FIRE SAFETY FOLLOW UP INSPECTION

Factory Name	Safaa Sweaters Ltd		
Address	Begumpur, Bokran, Monipur, Bhawl Gore		
Inspection Date	10/14/2015		
Date Report Received			
Date of 1 st Follow-up	24-May/16	Date of 2 nd Follow-up	19-July/16
Date of 3 rd Follow-up	21-December/16	Date of 4 th Follow-up	
Date of 5 th Follow-up		Date of 6 th Follow-up	
Inspected by	Mahfuza Khanom

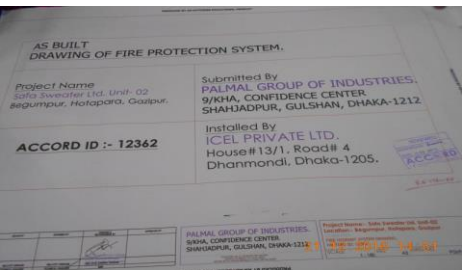
1	Proper certification was not available for fire rated doors installed in the factory.	Submit proper certifications for installed fire doors to the ACCORD for approval. If not available, or certification is not approved, install new, properly certified fire rated doors in accordance with ACCORD direction.	Immediately	<p>On 24/05/2016: Factory has installed fire door in factory building premises. During follow up inspection third party certification (UL) level was found on door leaf & accessories except door frame. Note: Doors which are needed to keep open, shall be interface (by electro-magnetic door holder device) with fire alarm control panel at required location.</p> <p>On 19/07/2016: Factory has shown the 3rd party certification as well as the approval mail conversation with Alliance.</p> <p>On 21/12/2016: Corrected as per previous follow-up inspection.</p>	10/06/2016	Corrected	Corrected
